ADDENDUM NUMBER TWO

October 31, 2011

RE: Westside Louisiana Technical College
25250 Tenant Road
Plaquemine, Louisiana 70764

CSK-01

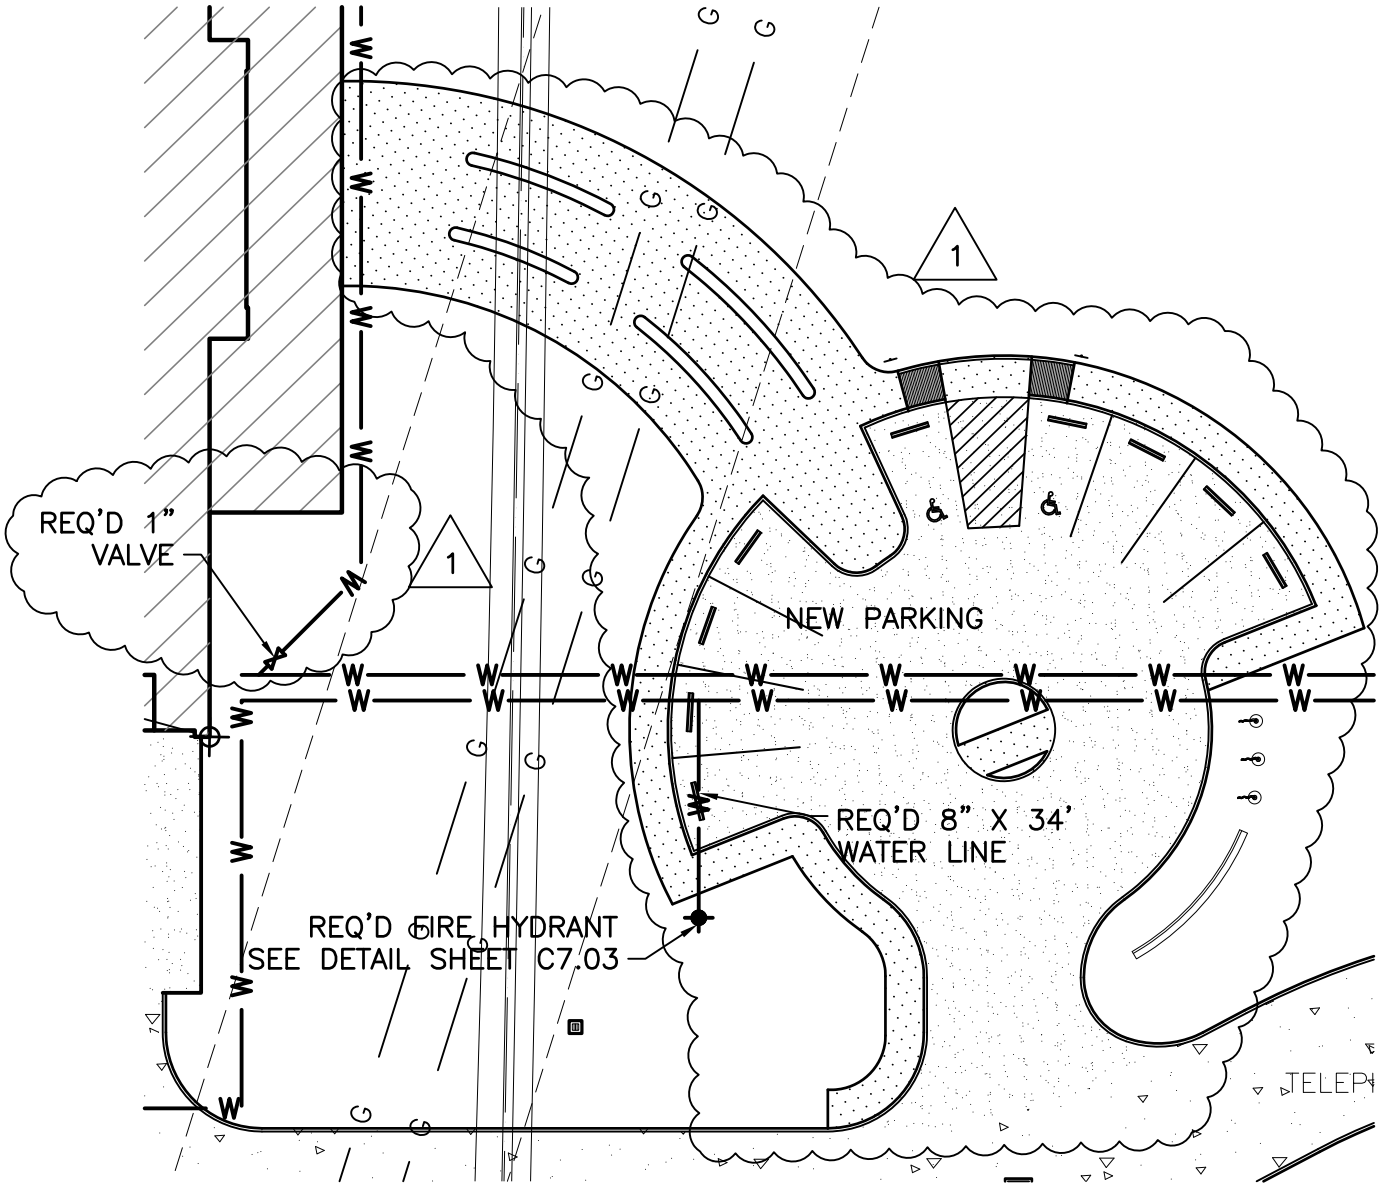
1. See revised Inset A. Note that the fire water line is to have a double check detector assembly backflow preventer. Please see CSK-01
2. The Exxon/Mobile pipeline servitude is wider than originally indicated. The visitor parking had to be moved outside of the servitude. Also, a 1" water valve was added. Please see CSK-02.

CSK-03

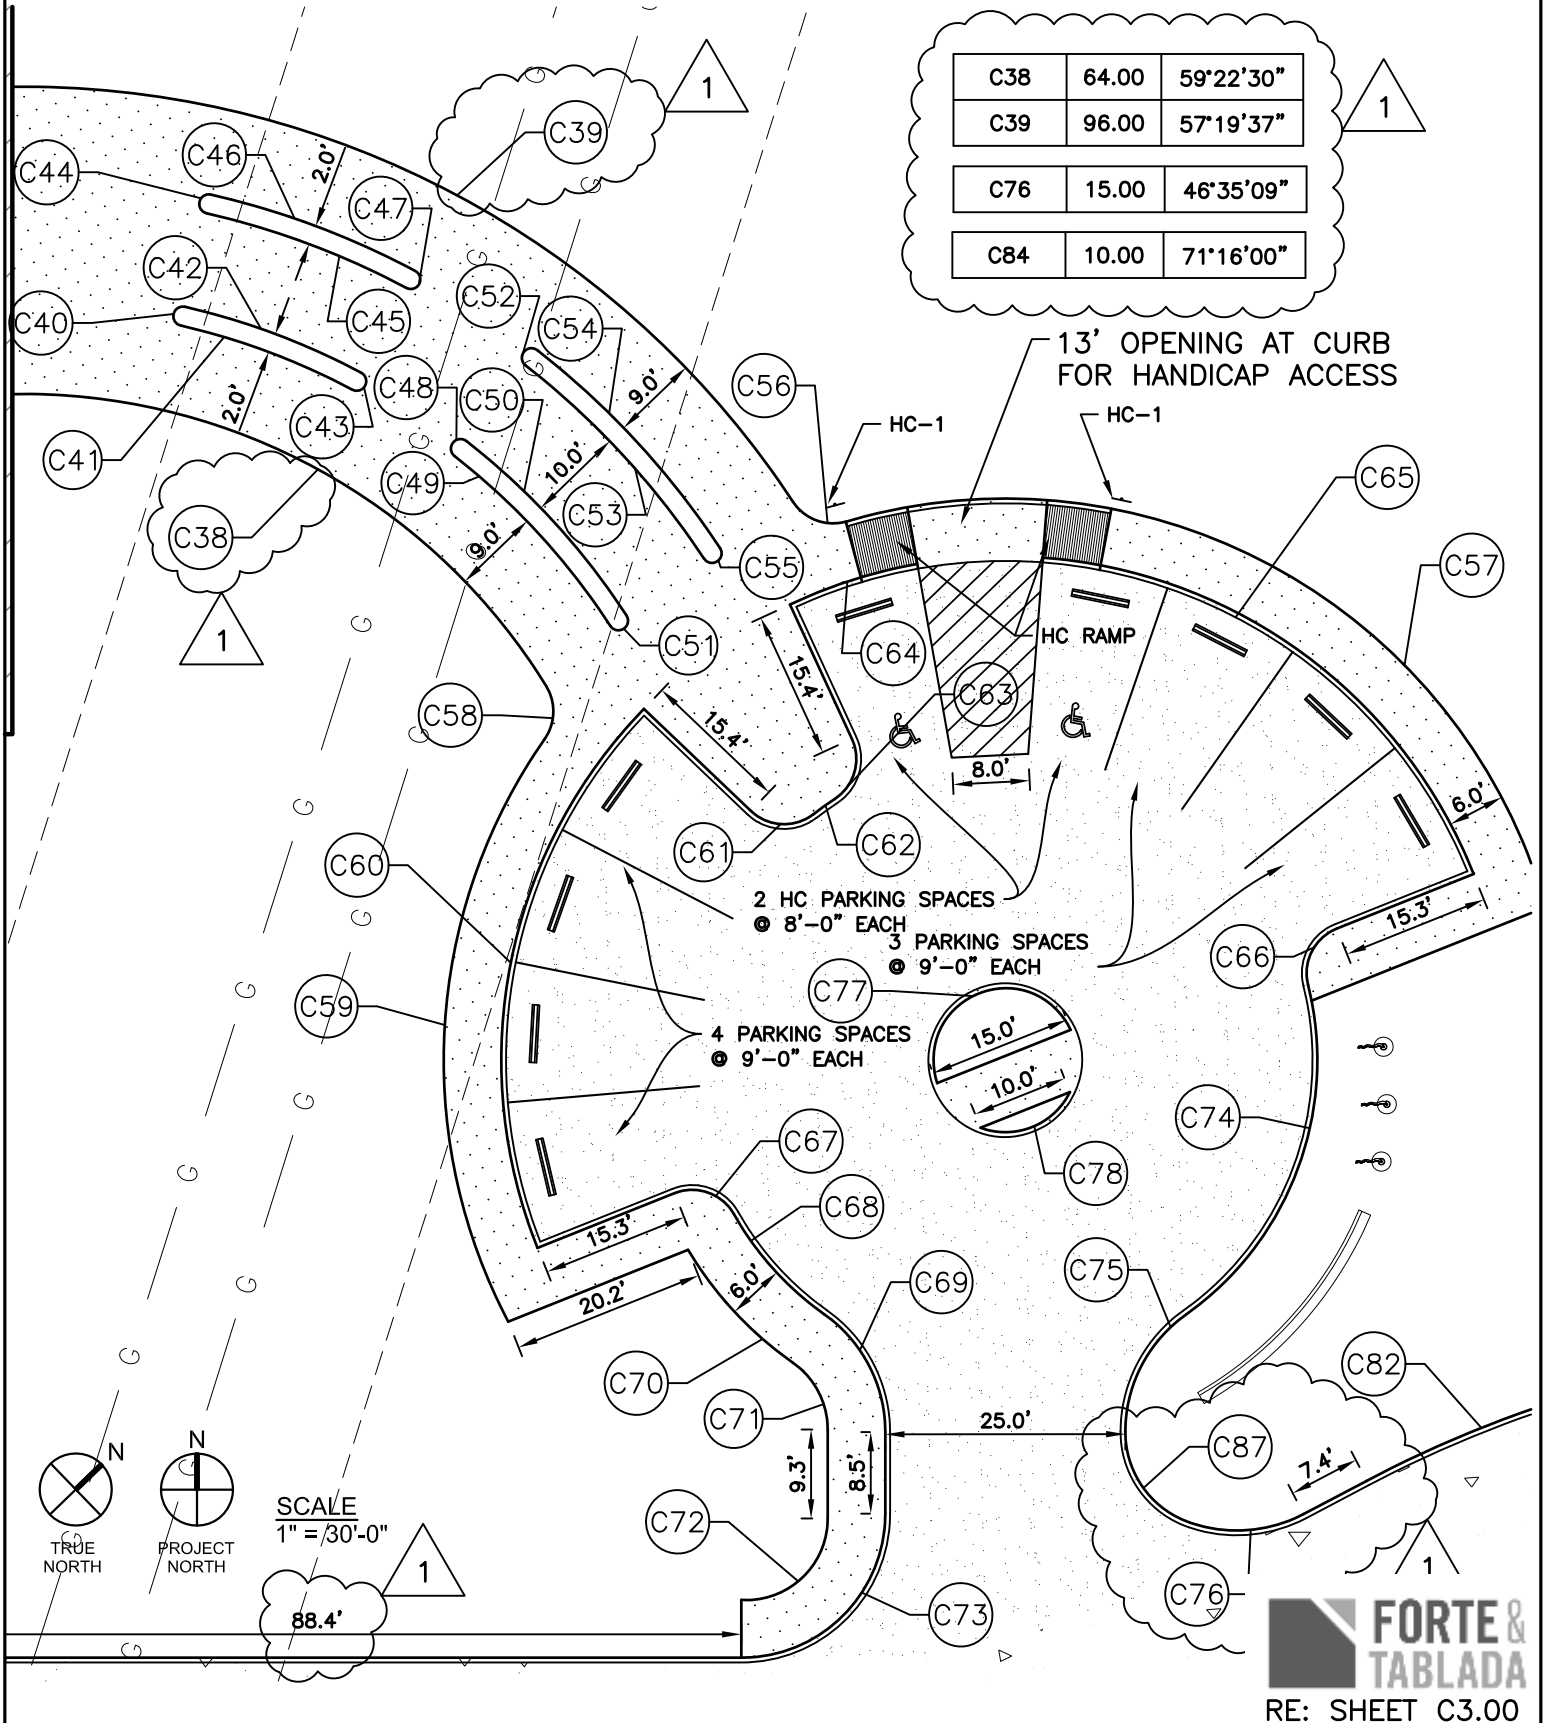
1. The Exxon/Mobile pipeline servitude is wider than originally indicated. The visitor parking had to be moved outside of the servitude. Also, a 1" water valve was added. Please see CSK-03, CSK-04, CSK-05, CSK-06, CSK-07

1ST FLOOR PLAN BASE BID - HVAC

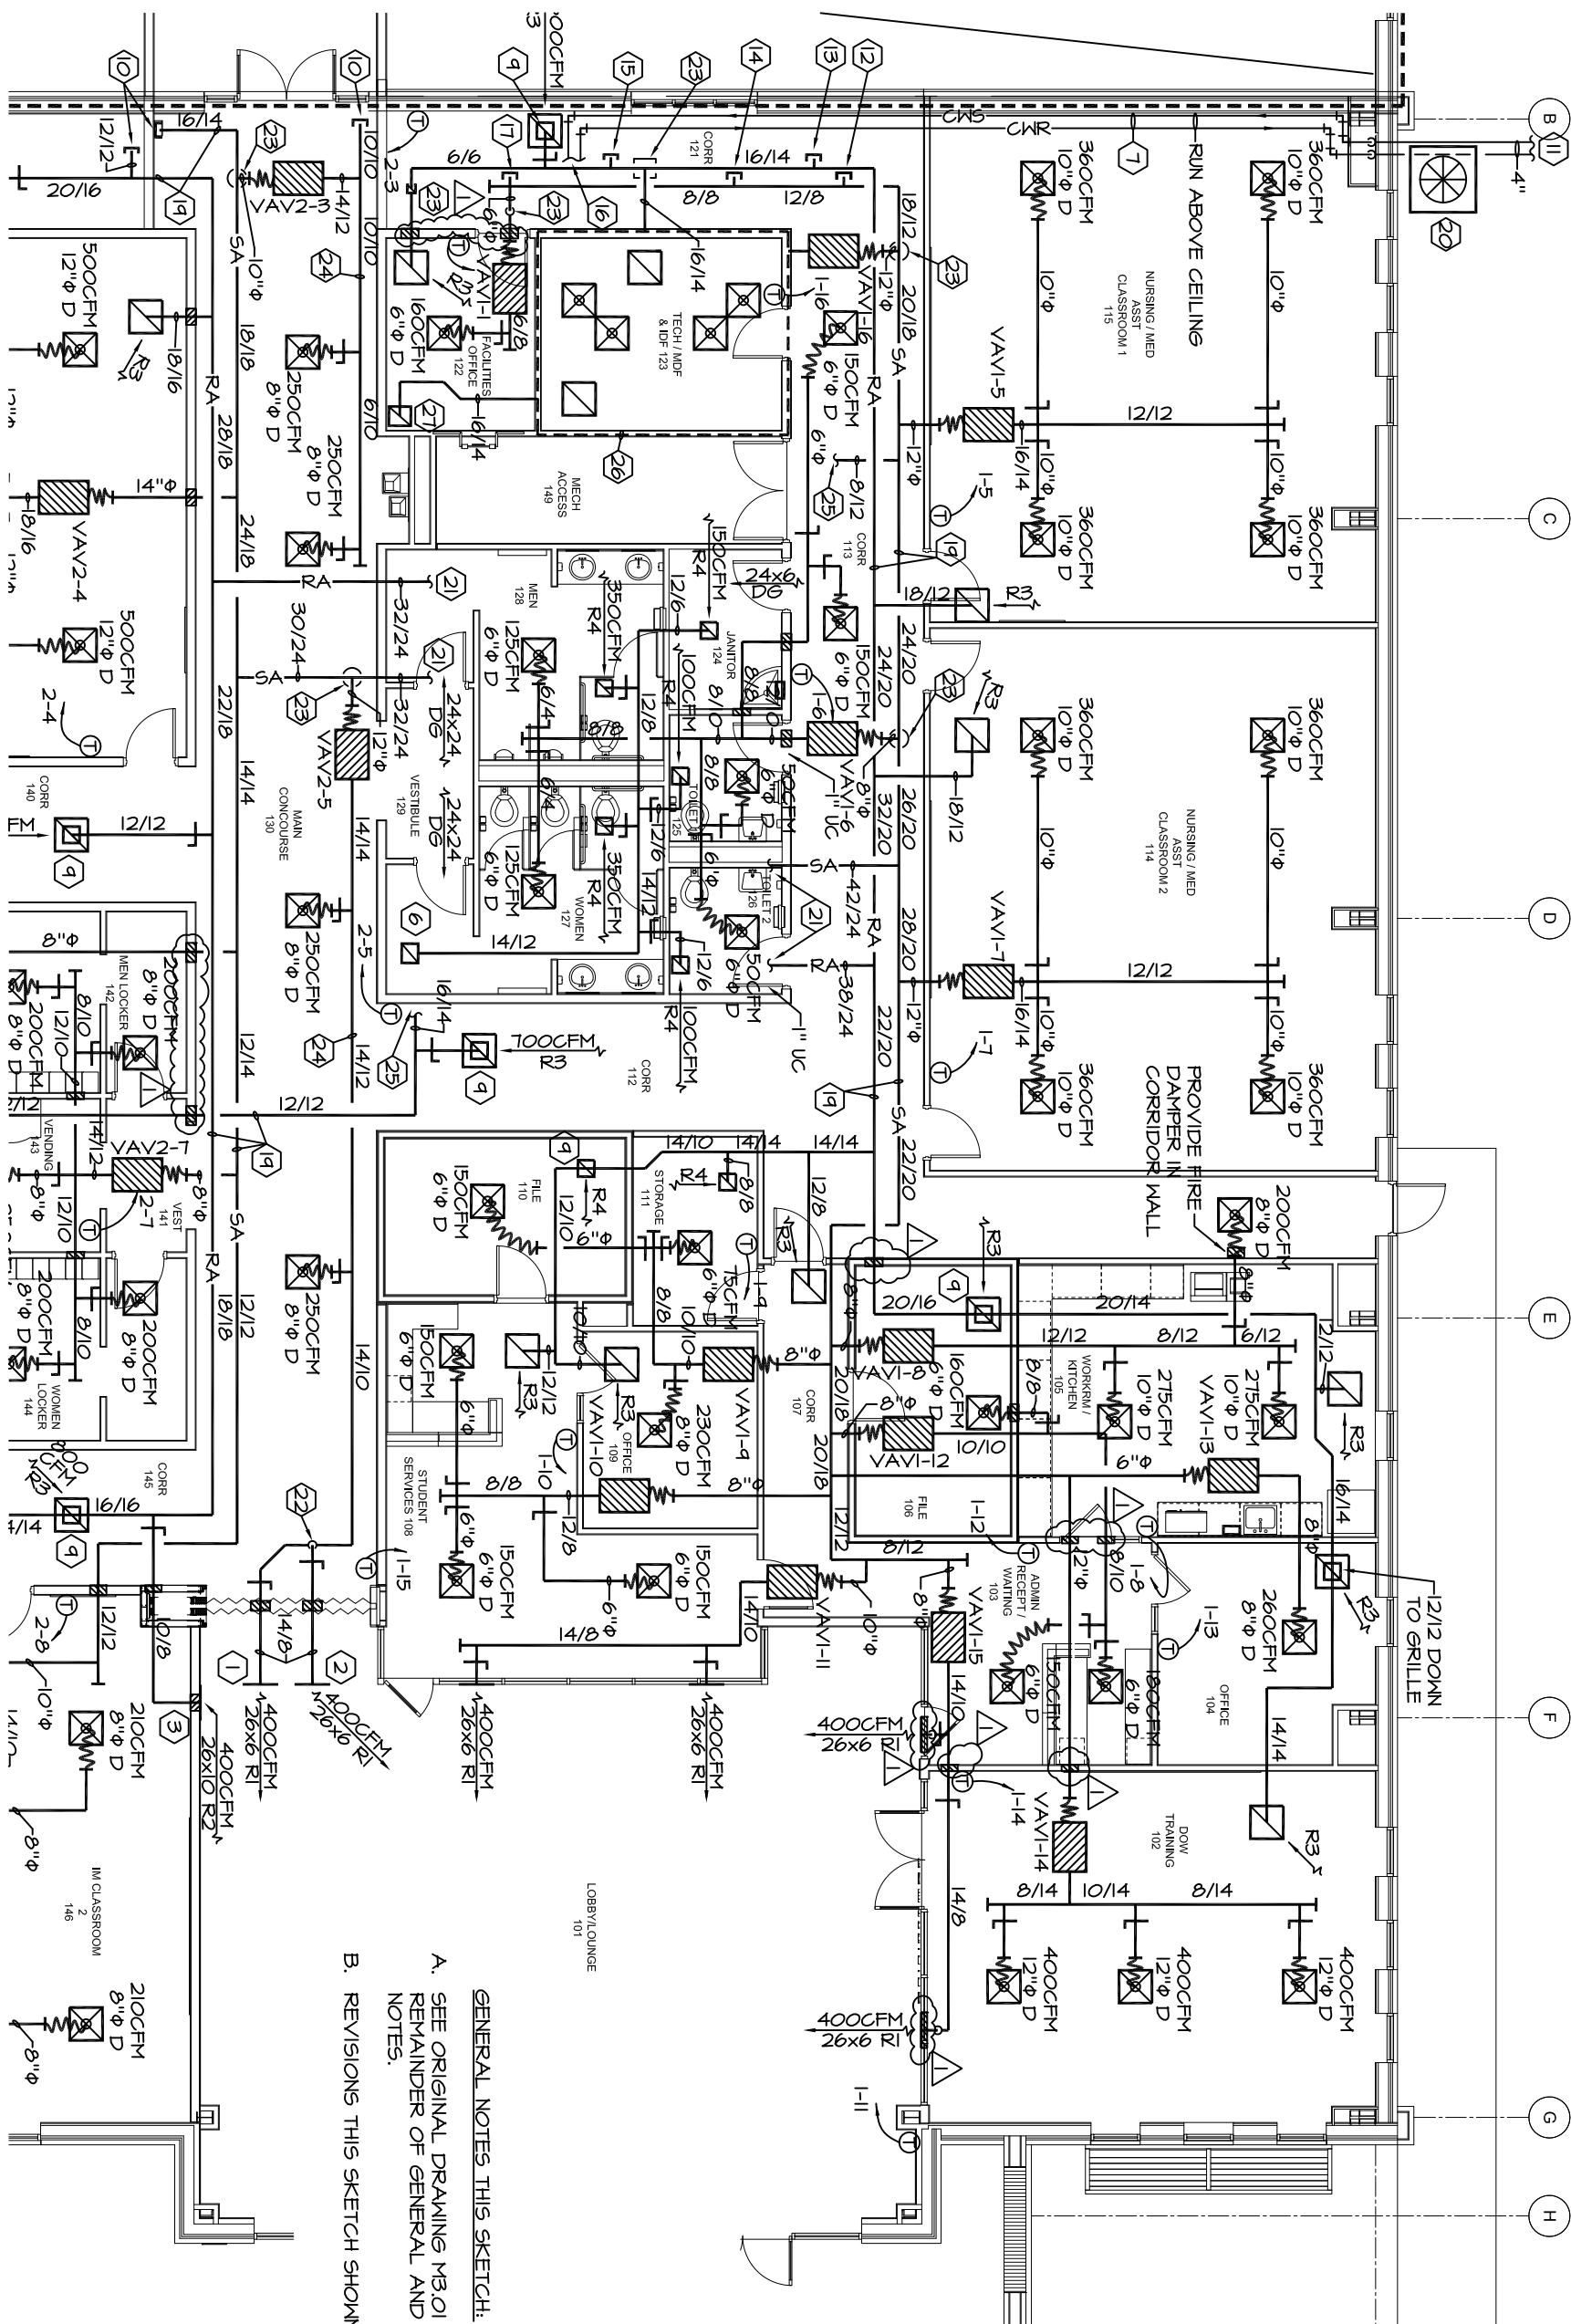
GENERAL NOTES THIS SKETCH:
 A. SEE ORIGINAL DRAWING M3.01 FOR REMAINDER OF GENERAL AND SPECIFIC NOTES.
 B. REVISIONS THIS SKETCH SHOWN BY ▲.

2 1ST FLOOR PLAN - HVAC - ADD ALTERNATE 2

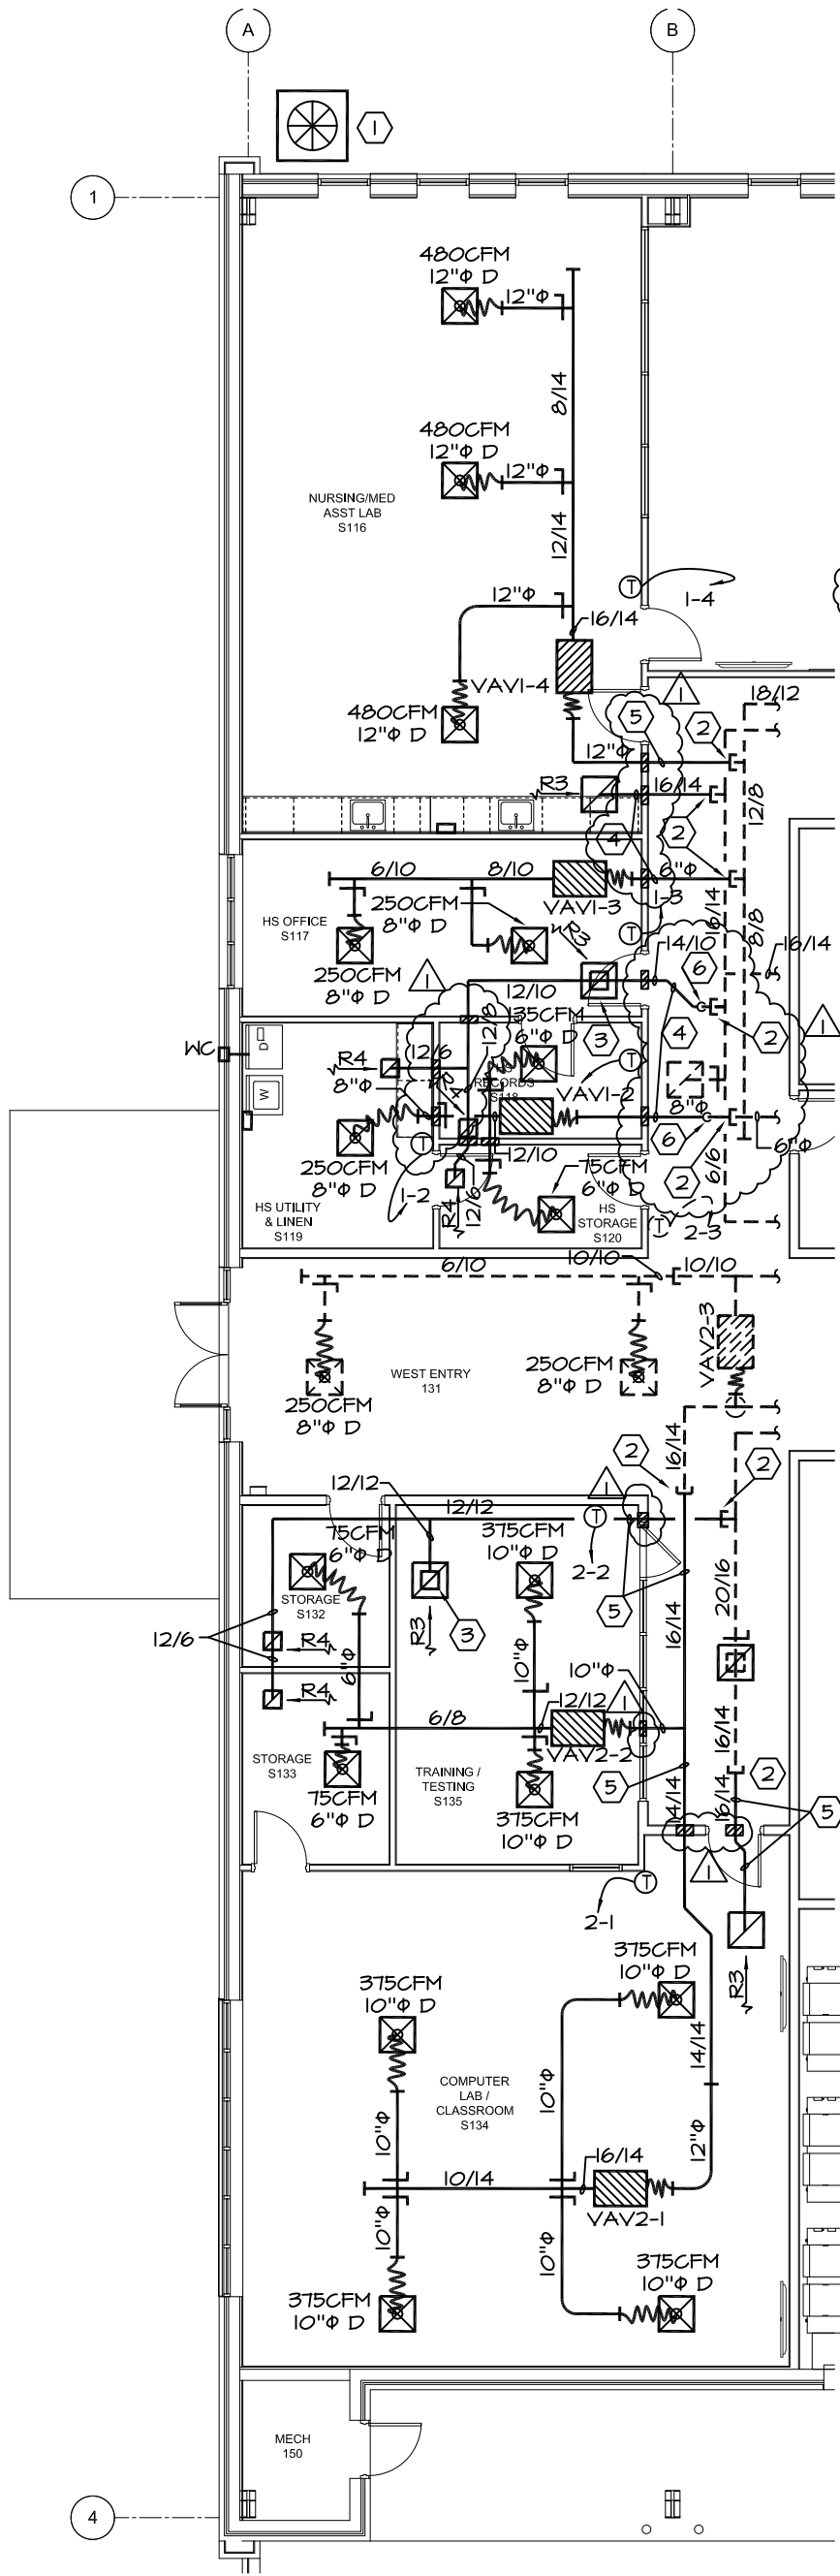
$\textcircled{6}$ DROP DUCT DOWN THRU FIRE RATED CEILING. PROVIDE FIRE DAMPER AT PENETRATION.
